7 Greville Place  
London NW6 5JP

Basement Impact Assessment  
Audit

For  
London Borough of Camden

Project Number: 12336-63  
Revision: F1

01 Distances to Neighbours  
scale: 1:100 15\_06

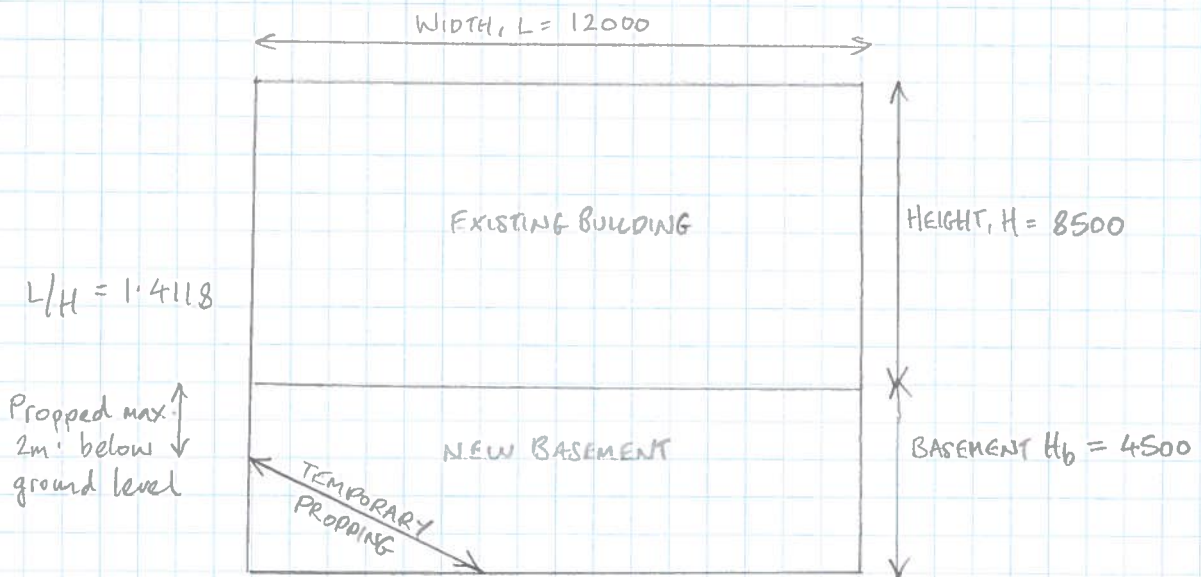
Query No	Subject	Query	Status	Design team comments <u>23/08/16</u>
5	Stability	Neighbouring property foundations not determined and the response provided is contradictory (see Audit paragraph 4.6 and 4.12).	Open- Clarification is requested. Neighbouring foundations to be established or maximum differential depth assumed.	To categorically define the foundations on the adjacent property, intrusive investigation would be necessary which would need to be agreed as part of the Party Wall Agreement. However it is noted that a BIA carried out for a nearby property of similar age and construction / type, has been previously accepted by Camden Council. That BIA made various assumptions regarding foundations. Previous basement work done to our study site didn't damage any of the neighbours' foundations. It is therefore considered that, given that these works will not be immediately adjacent to neighbouring structure, the works would not affect the adjacent properties (Please see attached Schneider Designers new drawings APL-101 and APL-305).

- APL-305 Distances Section – Section showing distances to neighbouring properties

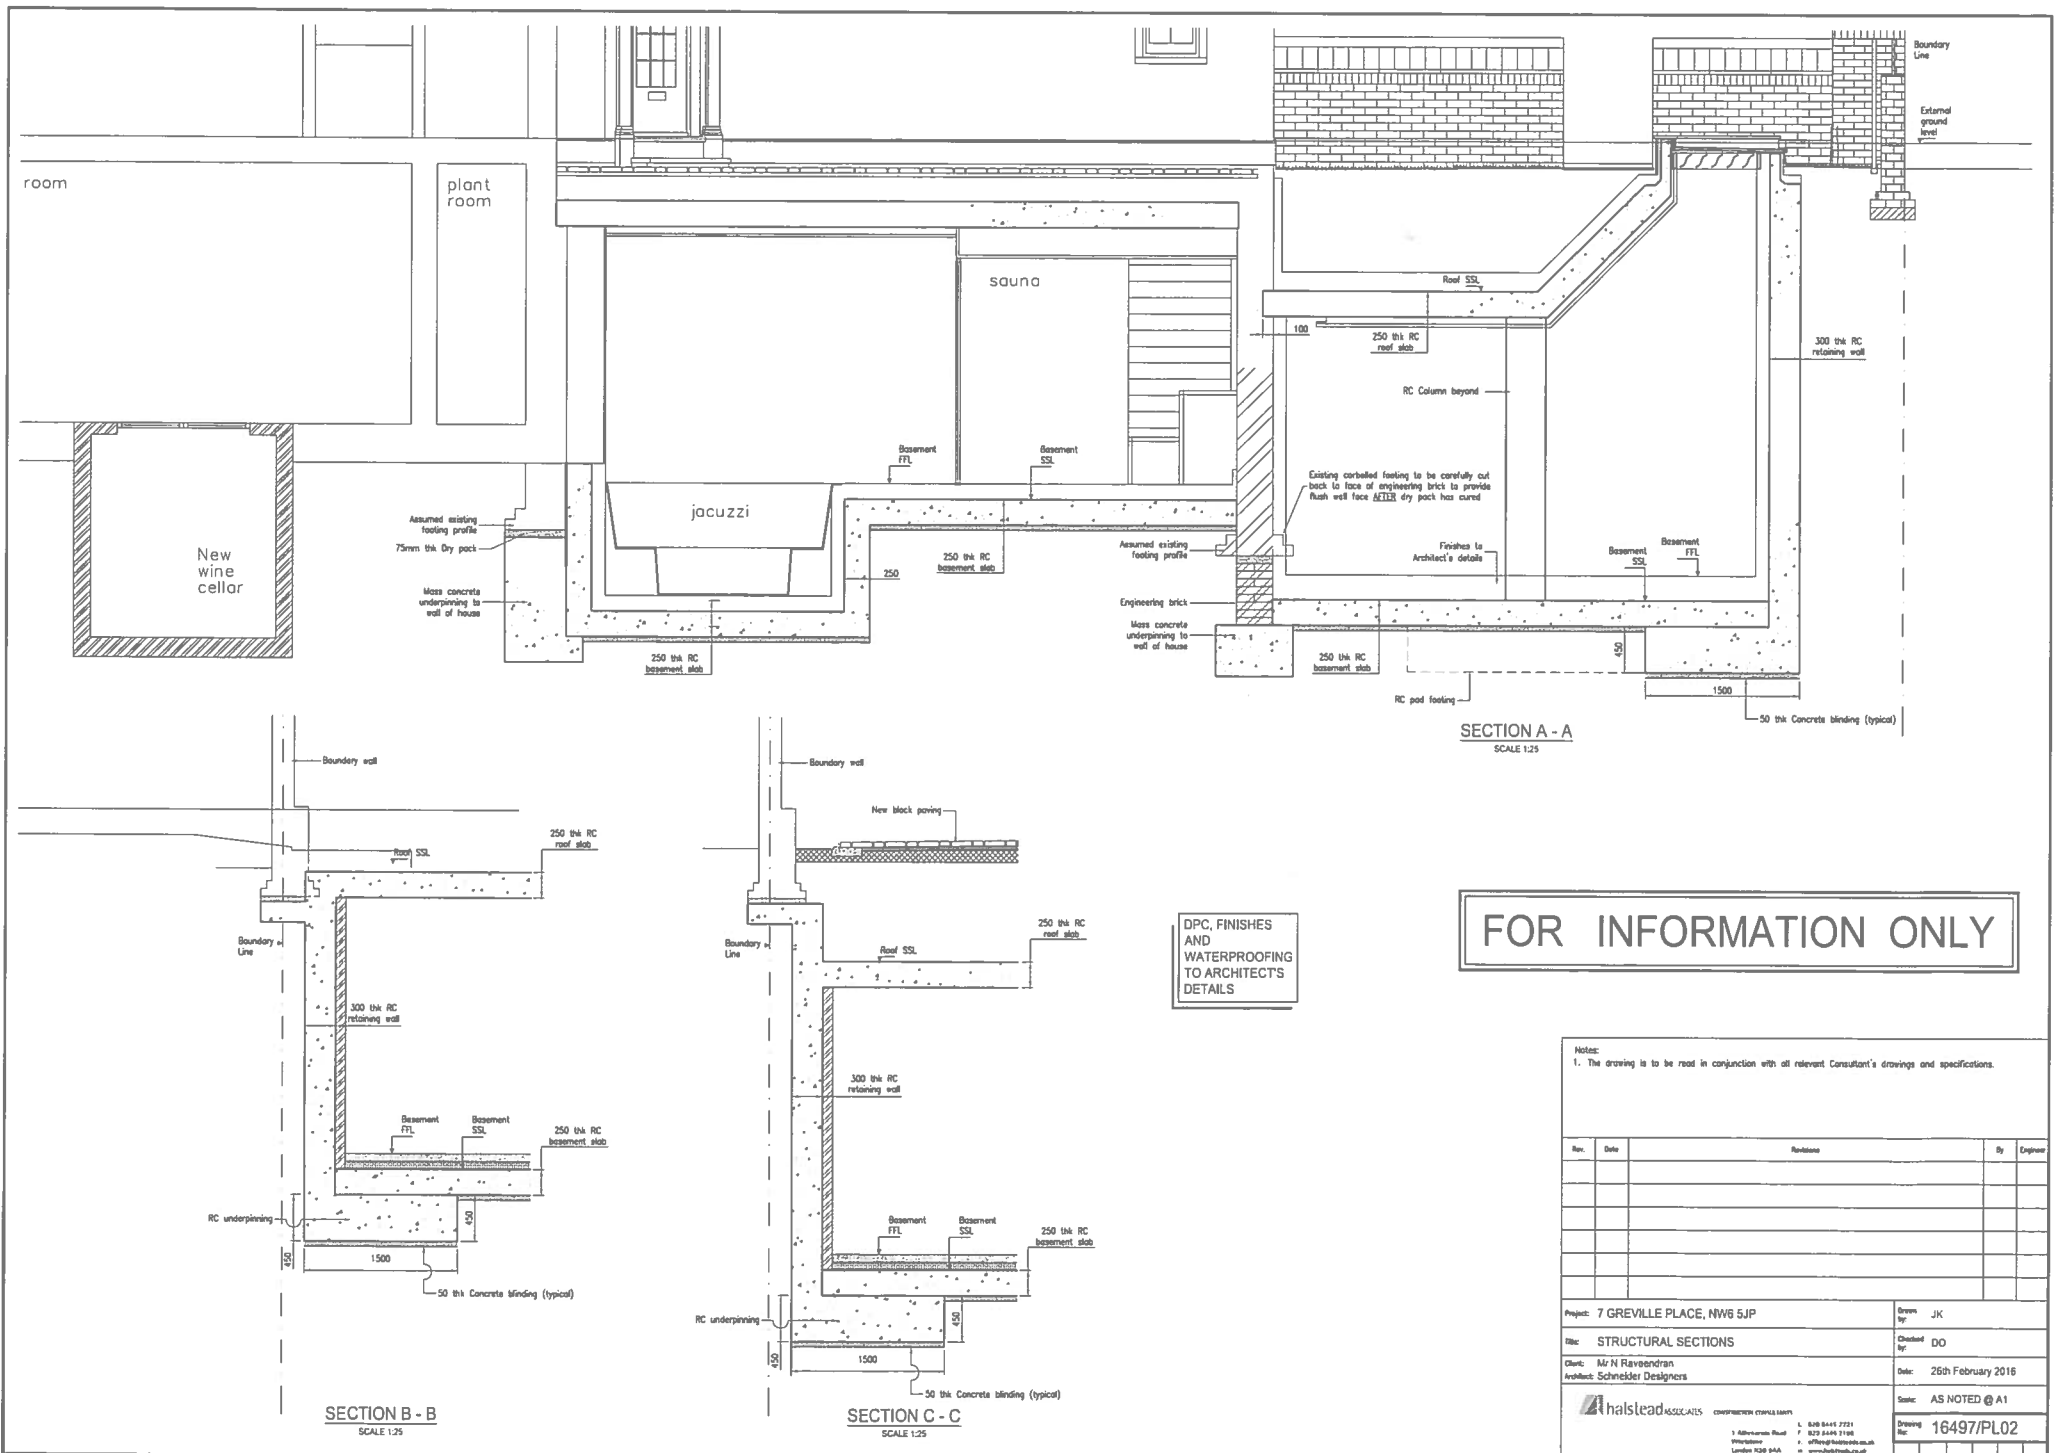
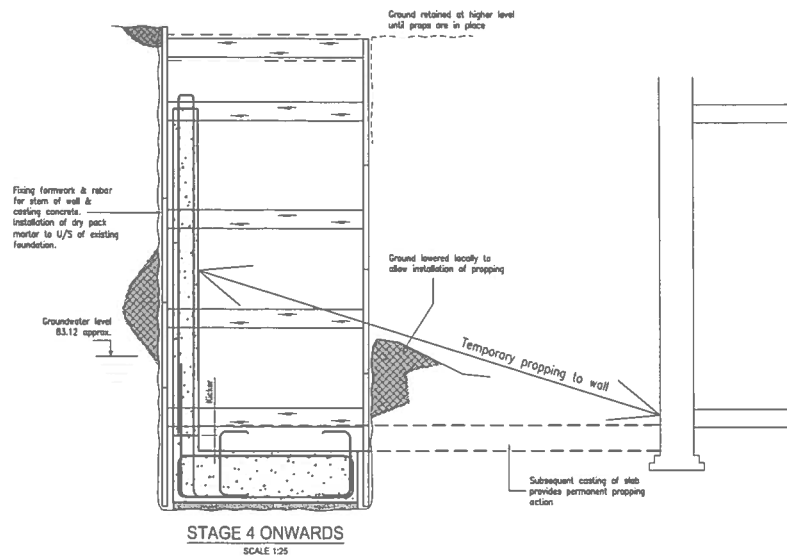
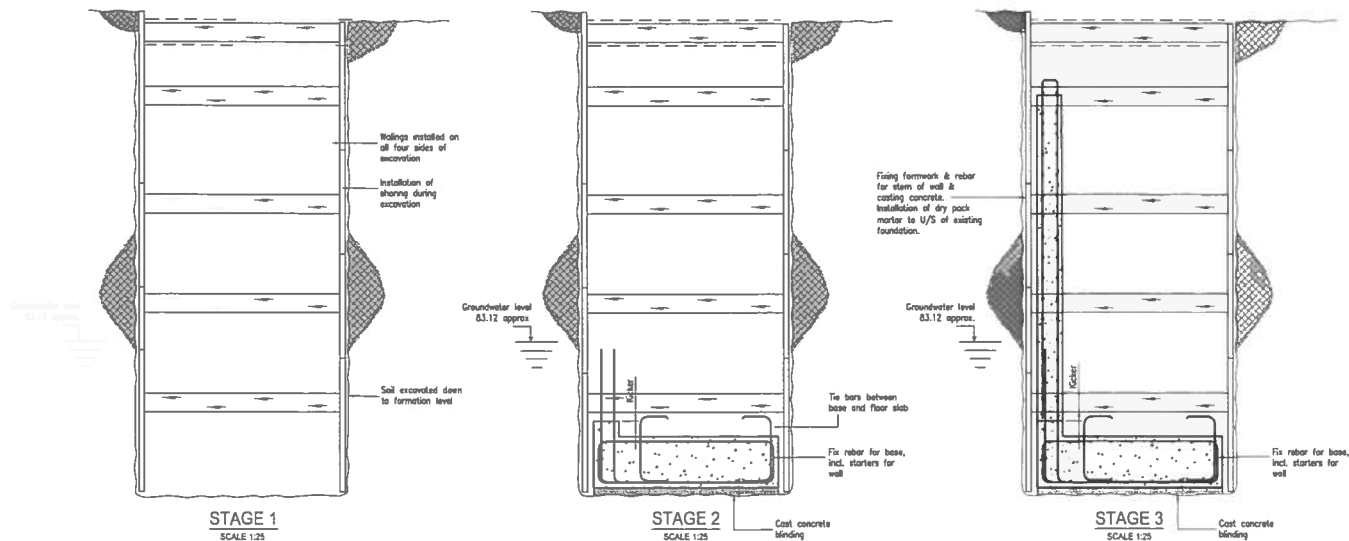
- 4.9. The proposed basement is to be formed by underpinning. It is stated that the construction of the walls of the new basement extension will involve “carrying out local excavations of around 1m in width and down to the formation level of the new basement”. A description of temporary works during construction and construction sequence was requested and has now been provided.

The sequencing of this work would be such that no more than 20% of a single wall elevation would be excavated at any given time. At the required excavation depth, suitable shoring would be required to provide a safe working area for site operatives. Typical sequencing for the excavation of a wall section is shown on Drawing No. 16497/PL03.

4.06            The Contractor will provide a method statement prior to commencement of work on site in which full details of hours, site set up and method for the formation of reinforced and under reinforced underpinning sections will be detailed. Drawing No. 16497/PL03 shows as indicative sequence for the construction of RC retaining wall "underpin" sections.
